Value Engineering Study Report

Georgia Department of Transportation

STP00-0218-01(001) – P.I. No. 522790 • CSSTP-0007-00(259) - P.I. No. 0007259

Jimmy DeLoach Parkway Extension – from I-16 to US 80 and US 80/

DESCRIPTION: **Use a 32' depressed median in-lieu of 44' depressed median**

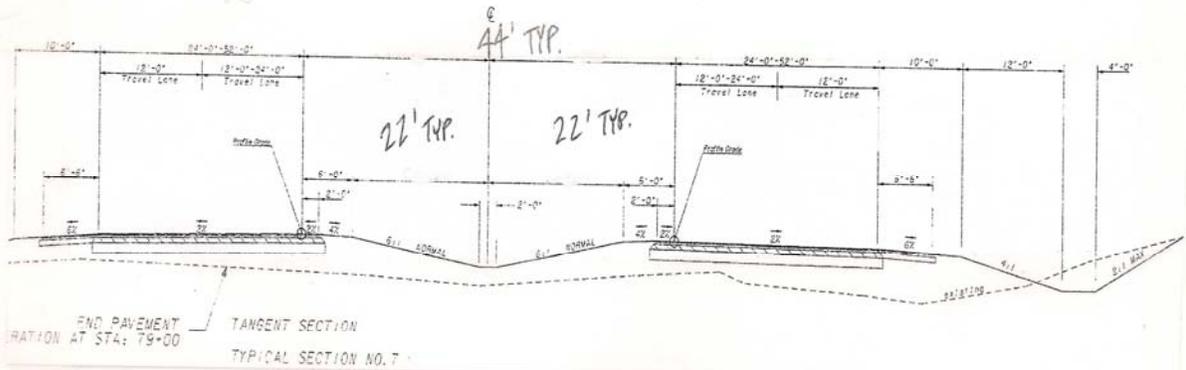
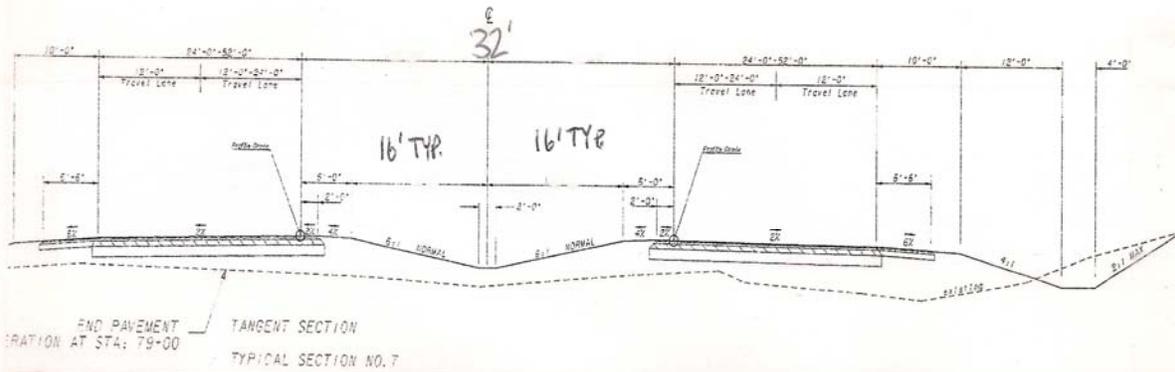
The original design calls for the construction of a 44' grassy, depressed median from STA 133+00 to the southern terminus of the project at I-16.

The alternative proposes constructing a 32' grassy, depressed median from STA 133+00 to the southern terminus of the project at I-16.

In Table 6.3 of GDOT Design Standards for Arterial Roadways, the table indicates that 32' medians are acceptable on four lane arterials with a 60 mph design speed. The alternative proposes narrowing the proposed 44' depressed median to 32'. The alternative appears to be acceptable by GDOT Design Standards, and appears to be functionally equivalent.

DESCRIPTION: Use Type "A" in-lieu of a Type "B" south bound left turn
lane onto driveway at STA. 107+00

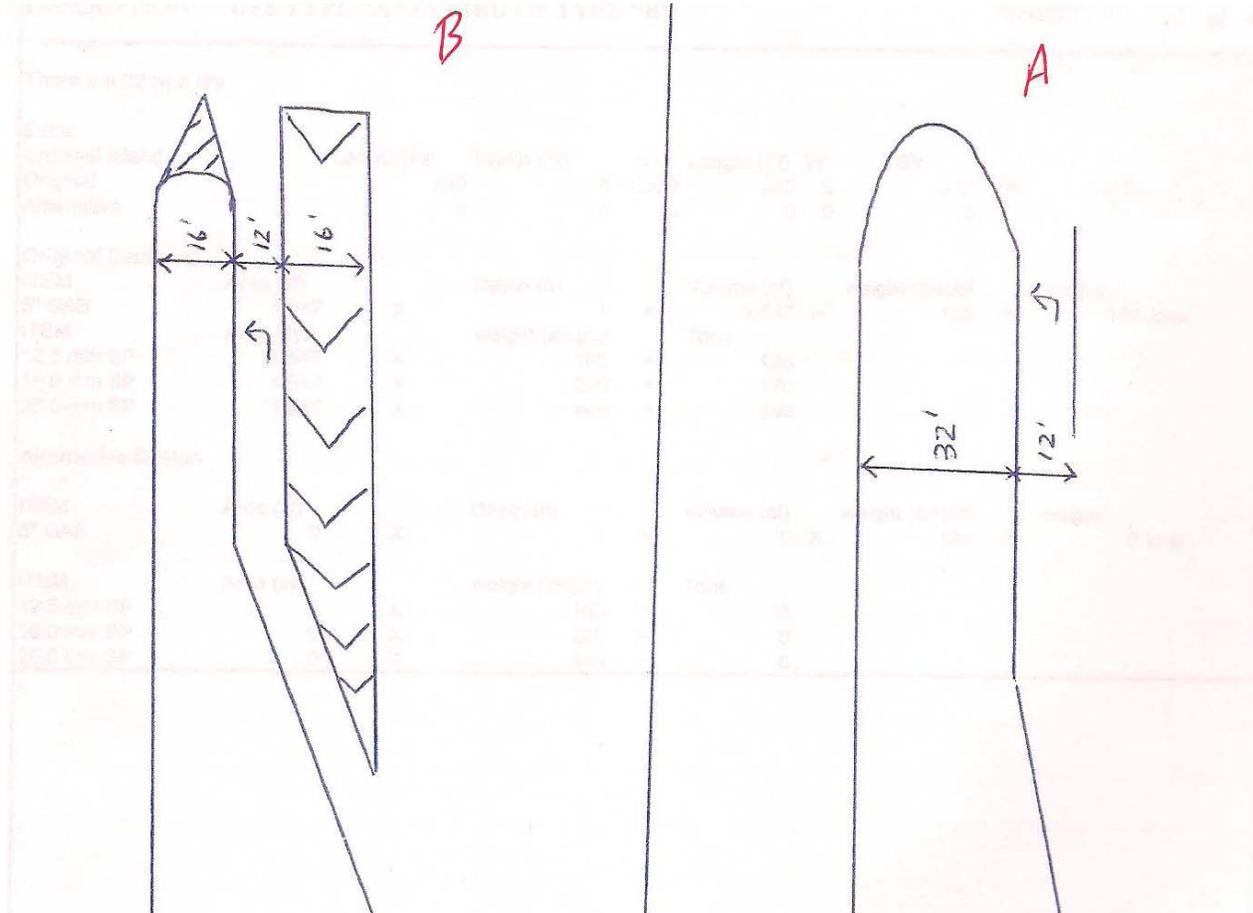
The original design proposes using a Type "B" median left turn lane at STA 107+00 on the northbound and southbound lanes which would serve possible future driveways.

The alternative design proposes using a Type "A" median turn lane at STA 107+00 on just the southbound lane.

The GDOT Standards state that Type "B" median crossovers are the preferred type of median crossover; but that Type "A" median crossovers can be used as the situation may allow. At this particular location, the median turn lane is being provided for a future driveway to access the adjacent properties. The south bound traffic will be heading downhill therefore would have a greater sight distance than if this were on level or uphill grade.

DESCRIPTION: **Lower Profile Grade over the CSX Railroad Crossing**

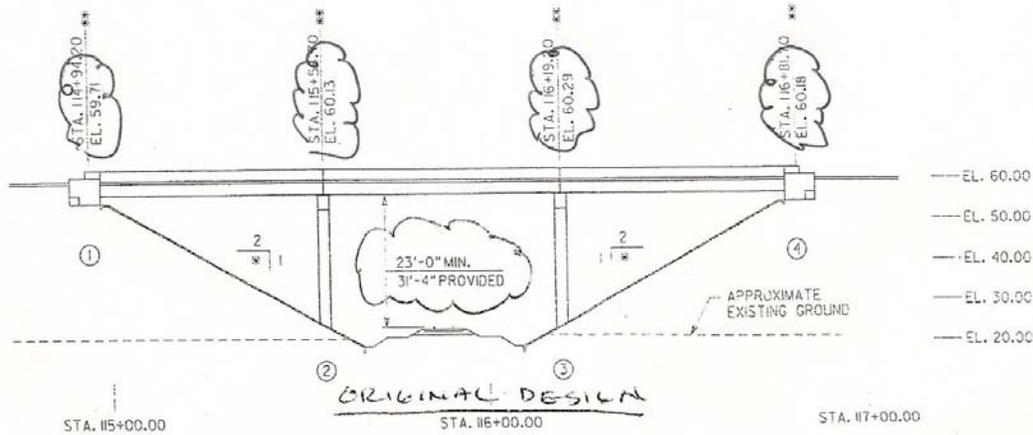
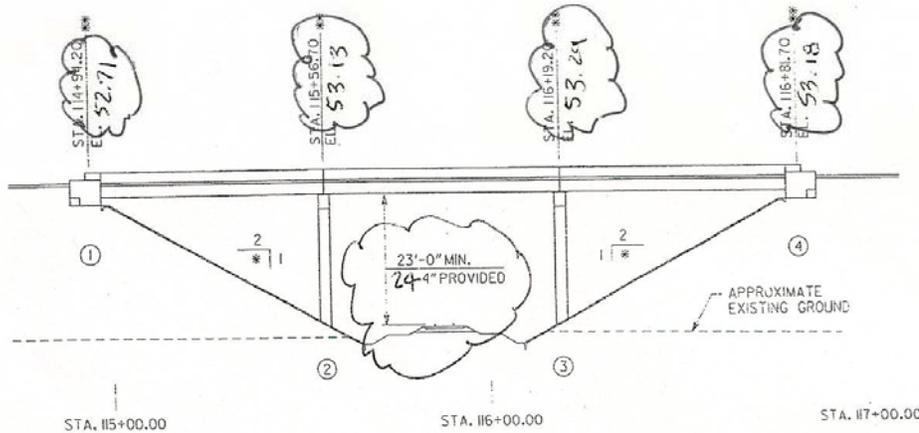
The original design provides 31'-4" of clearance over the CSX railroad.

The alternative proposes reducing the clearance to 24'-4".

The proposed bridge height provides 31'-4" of clearance over the CSX railroad. The current minimum standard height clearance is 23'-0". Therefore, it appears reasonable to reduce the height.

DESCRIPTION: **Relocate or delete southbound U-turn at STA. 44+00; use
separate structures for Little Ogeechee River Bridge**

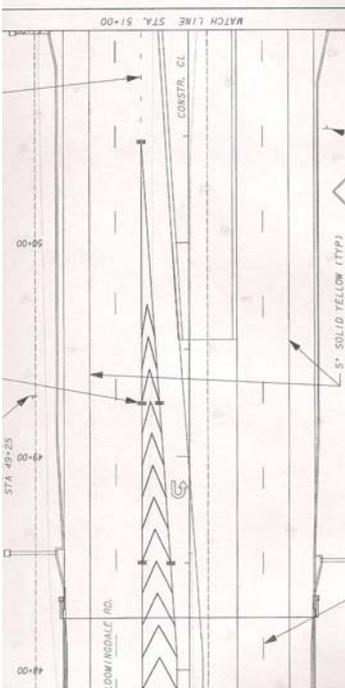
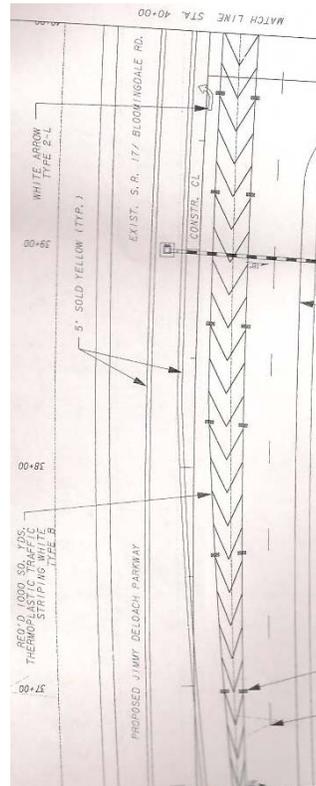
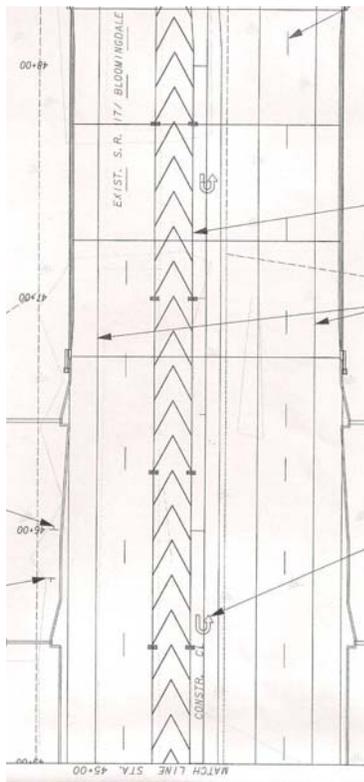
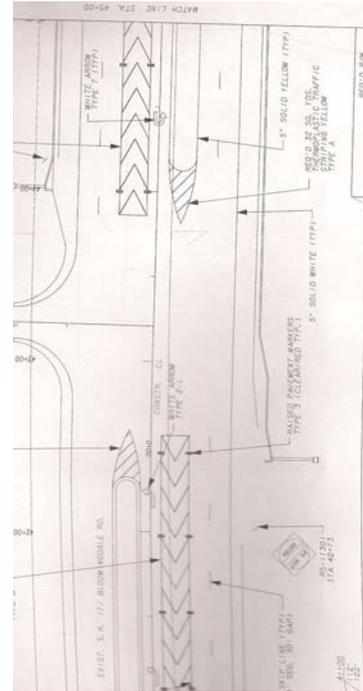
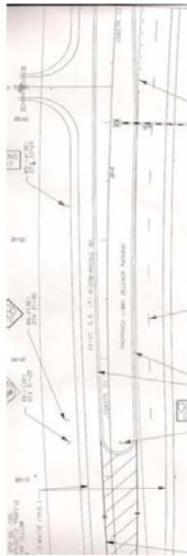
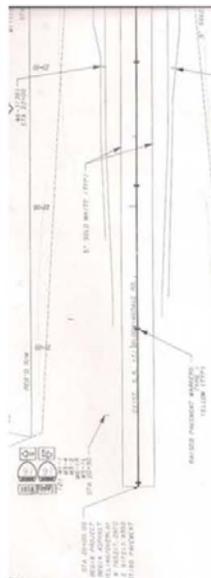
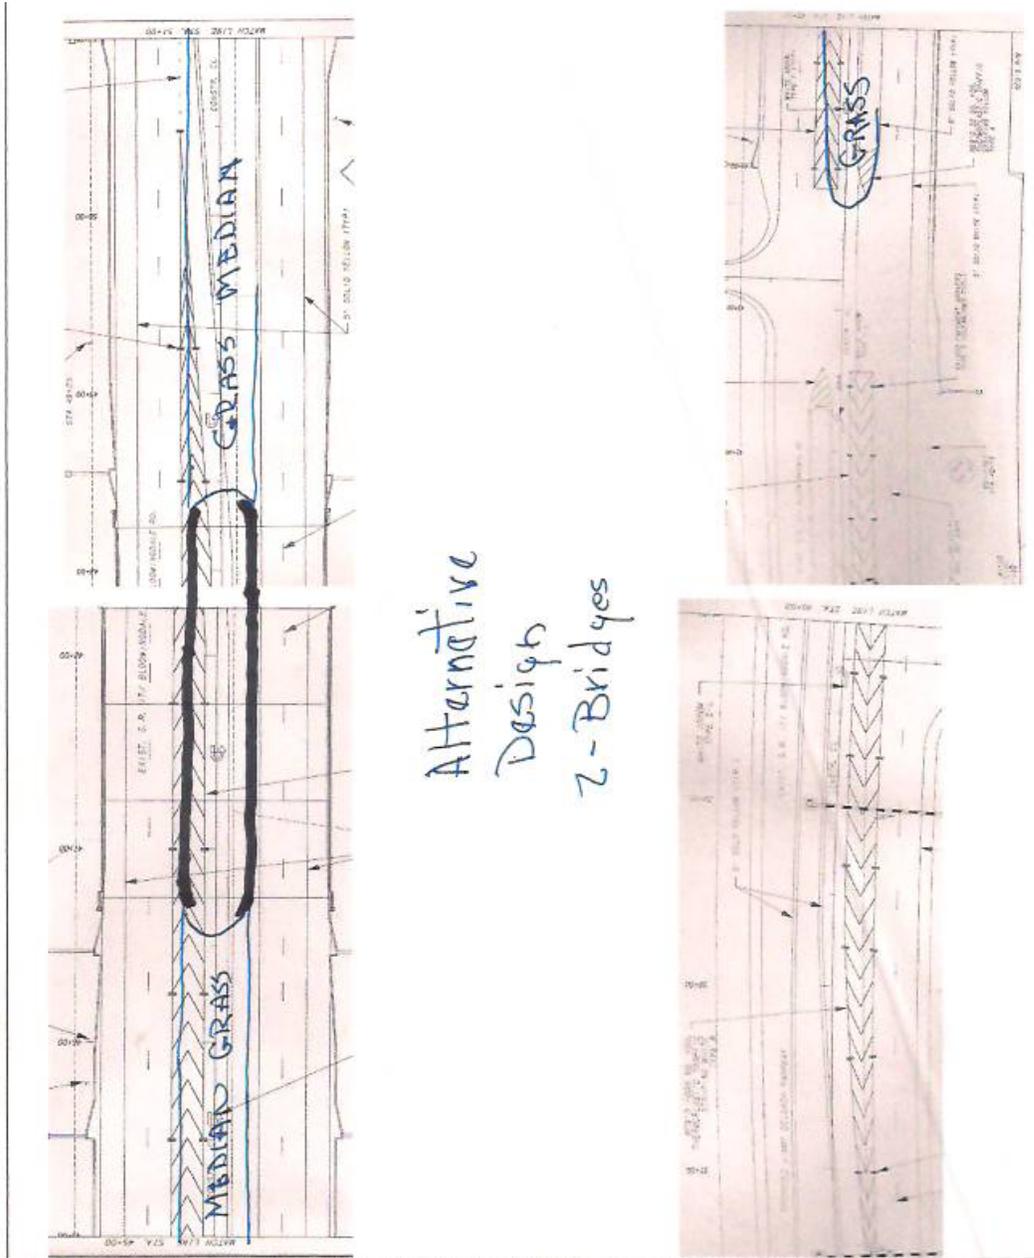
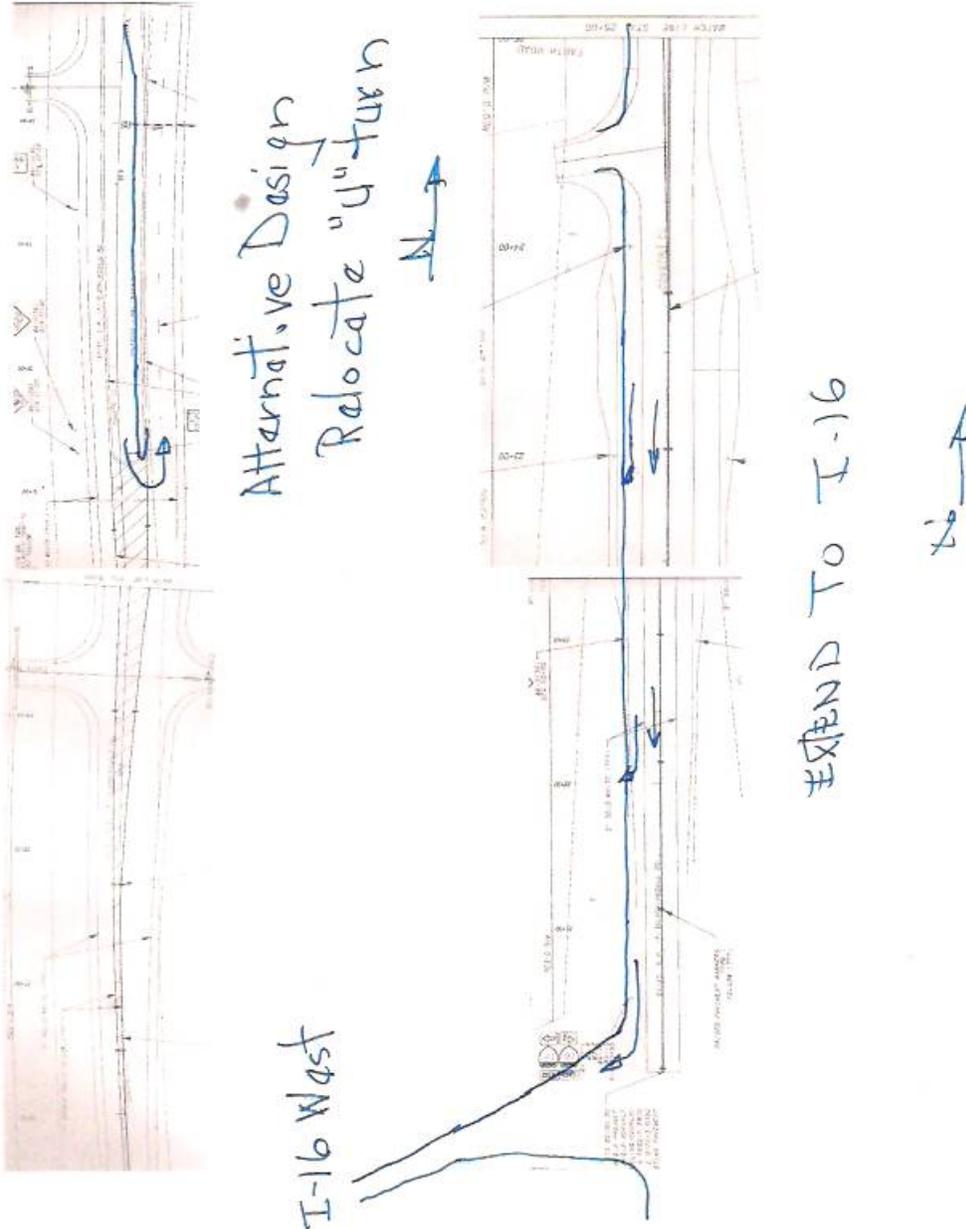
The original design calls for a southbound to northbound U-turn at STA. 44+00. To allow for this activity at this location, the original design called for a single structure to carry the Jimmy DeLoach Parkway across Little Ogeechee River. The proposed bridge is 150'-0" in length and made up of three 50'-0" spans. To accommodate the 4 – 12' travel lanes, the 44'-0" median which includes the type "B" southbound U-turn lane, 10' outside shoulders, and a standard concrete safety barrier. the bride was designed as a single structure with an out-to-out width of 115'-3".

The alternative proposes relocating or deleting the southbound U-turn lane and constructing separate structures to be used for the northbound and southbound traffic.

DESCRIPTION: **Relocate or delete southbound U-turn at STA. 44+00; use
separate structures for Little Ogeechee River Bridge**

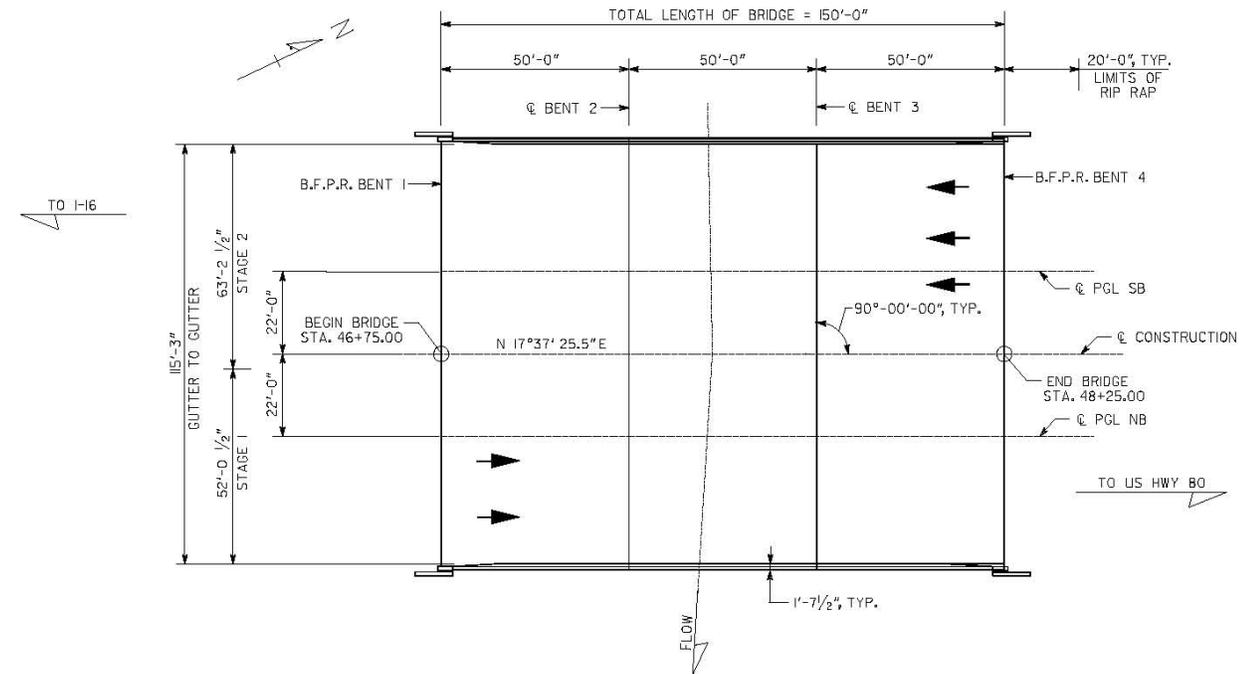
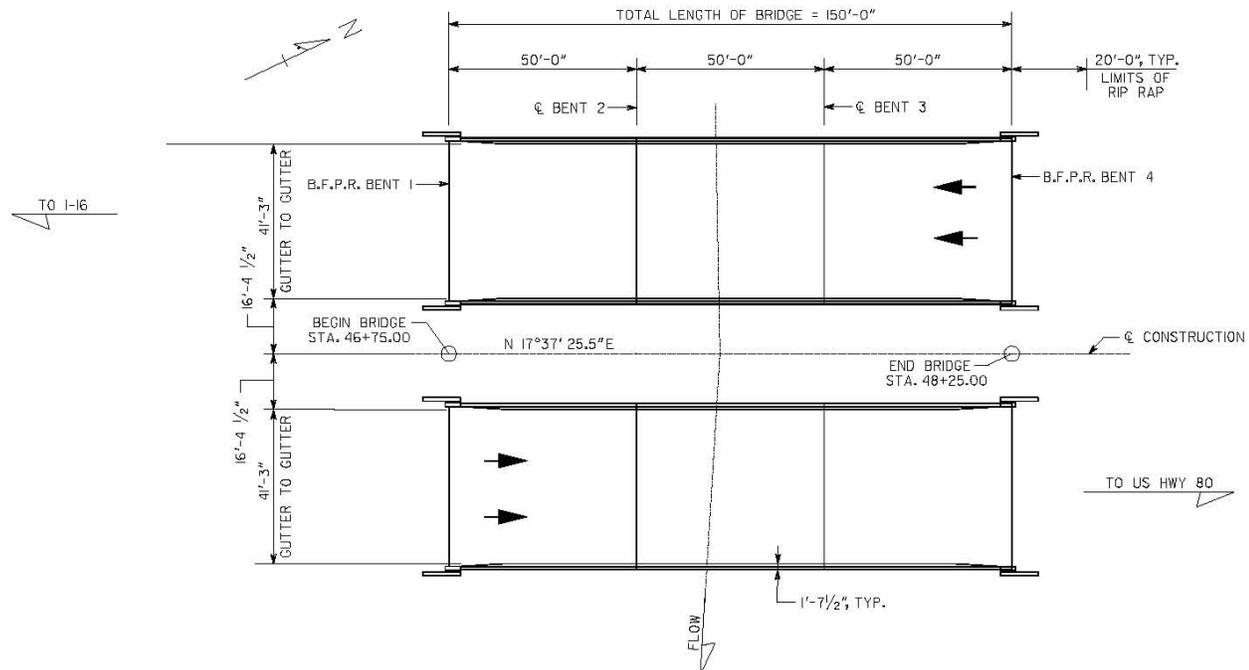
The proposed location of the southbound to northbound U-turn at STA. 44+00 impacts the existing wetlands and resulted in a full width single bridge at STA 46+50 to cross the Ogeechee River. The drawings at STA 31+00, propose another median opening. This median opening could also be modified to provide the function of the U-turn lane. It is noted that perhaps placing the U-turn at STA 31+00 could also be a clean method to "drop" the inside southbound lane. This modification could also be included and used to "offset" and the cost and allow the extension of the two (2) southbound lanes to the existing I-16 westbound on-ramp where the "second" lane could be "dropped" thereby not impacting any future improvements of this interchange; and possibly allow reconstruction of the I-16 interchange to be postponed as this modification would may extend the life of the existing interchange by providing a smooth and expedient movement of truck traffic.

As this U-turn is relatively close to the end of the project, it may be reasonable to delete the U-turn.

DESCRIPTION: **Provide single span bridges with MSE walled abutments
at CSX RR crossing**

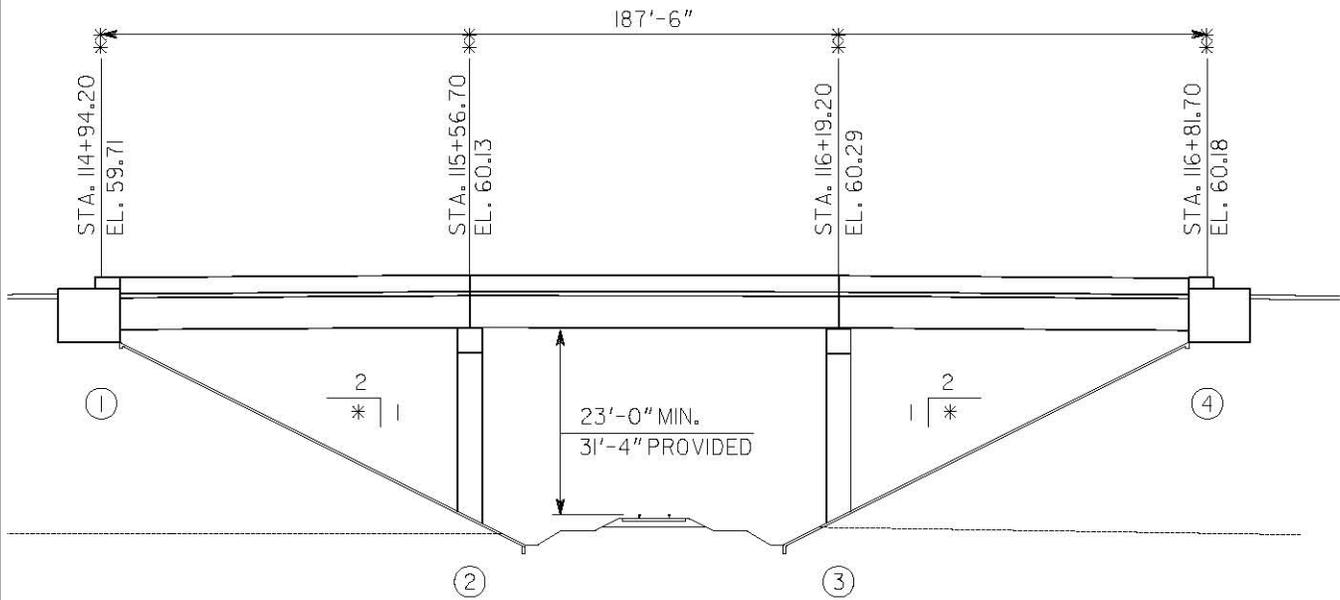
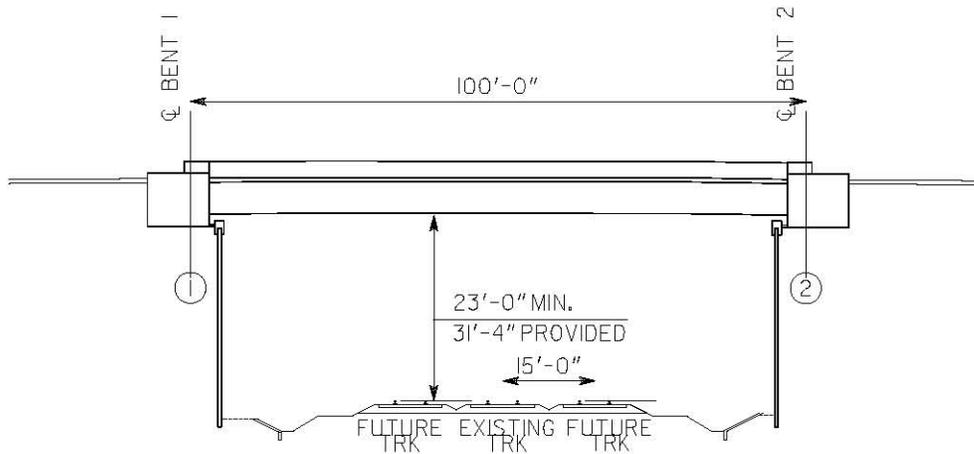
The original design calls for a dual structure carrying Jimmy DeLoach Parkway across CSX RR. The bridges are 187'-6" in length, made up of three 62'-6" spans. The out-to-out width of the northbound bridge is 41'-3", accommodating 2 – 12" travel lanes, 10' outside shoulder, 4' inside shoulder and standard concrete safety barriers. The southbound bridge is tapered to accommodate a turn lane and varies in width from 46'-1 7/16" to 55'-4 3/4".

The alternative proposes providing MSE Walled Abutments and eliminating the end spans on both bridges. All vertical geometry remains the same.
